Mack Trucks, Inc.
Greensboro, NC USA

Service Program Trucks

Static Fill Coolant Pipe

PI0790, Static Fill Coolant Pipe

W2073199

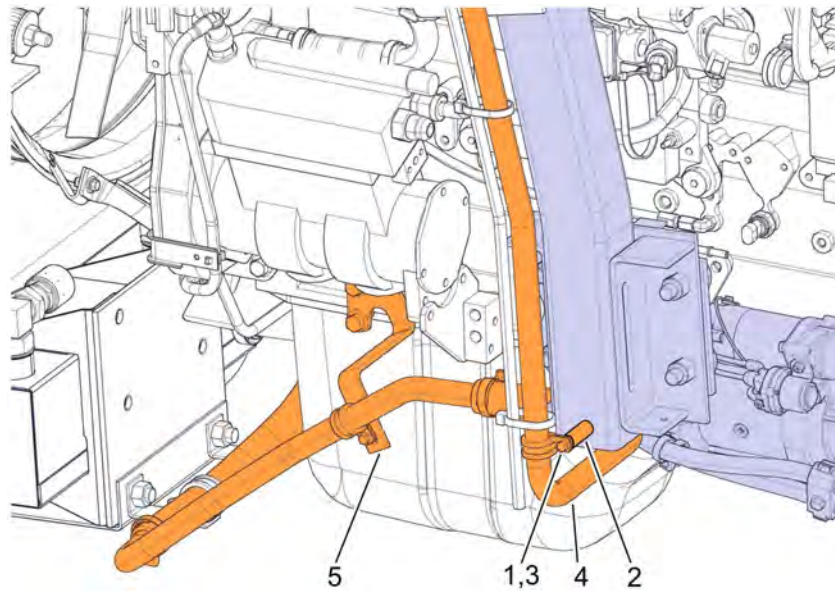
The static fill coolant pipe from the expansion tank can make contact with the starter solenoid wire and rub through the wire insulation on some MACK LEU and MRU trucks equipped with a Cummins ISL-G natural gas engine. A spacer (part number 25106640), fastener (part number 995455), and nut (part number 990939) will be used to relocate the static fill pipe away from the starter solenoid wire. Additionally, if any starter solenoid wires are exposed, the starter must be replaced with a new starter (part number 21398109).

Static Fill Coolant Pipe Parts			
Item #	QTY	Part Number	Description
1	1	995455	Fastener, M6 X 50
2	1	25106640	Spacer
3	1	990939	Nut
4	1	N/A	Static Fill Coolant Pipe
5	1	N/A	Stand-Off Bracket

W2073203

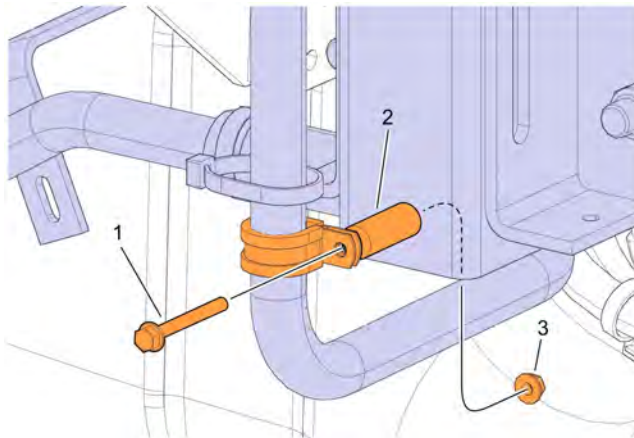
- 7 Assemble the spacer (part number 25106640, Item 2), fastener (part number 995455, item 1), nut (part number 990939, item 3) and p-clamp onto the static fill pipe and stanchion. Tighten fastener to 10 ± 1.5 Nm (89 ± 13 in-lb).
